RE: College Place Elementary and Middle School Replacement (PDR-25-0005) – First Review Comments

PDR Plan Set Part 2 Site Plan Sheets L1.00-L1.07:

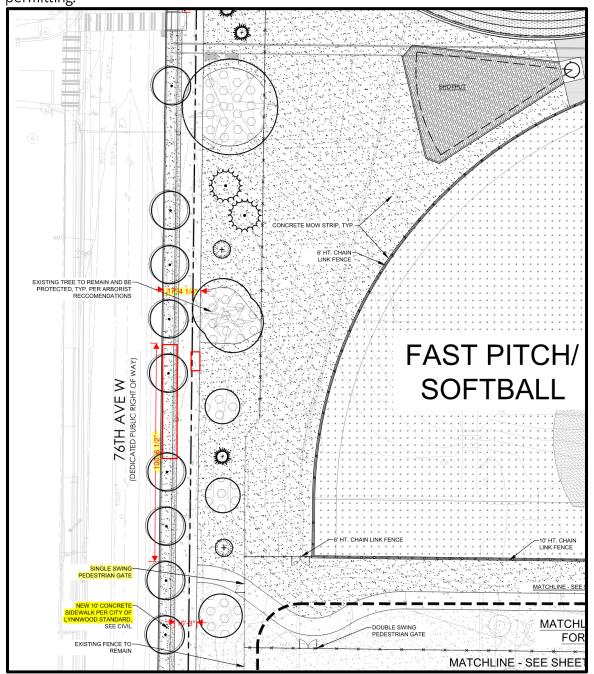
I am submitting the following request for a bus stop at the College Place Elementary and Middle School. The redevelopment will impact an existing Community Transit bus stop that is along the frontage of 76th Ave W. Community Transit requests the following, and the approximate location shown on the image below.

CT recommends relocating the bus stop approximately 145 ft south of the shown pedestrian crossing, which is approximately 100 feet north of the pedestrian path onto school grounds (highlighted below). This will improve overall access for students, faculty, and staff accessing the school by relocating the stop to a direct access pathway to the school.

A question for the City, would we be able to co-locate a bus stop pad in the extended sidewalk area (shown as the red box below)? This would maintain an approximately 6.5 ft wide pedestrian access route while allowing for bus stop infrastructure, such as a shelter and bench, to be located at the stop without asking for an additional bus stop pad.

If this is not possible, then CT requests a bus stop pad to be located in the same location at back of sidewalk.
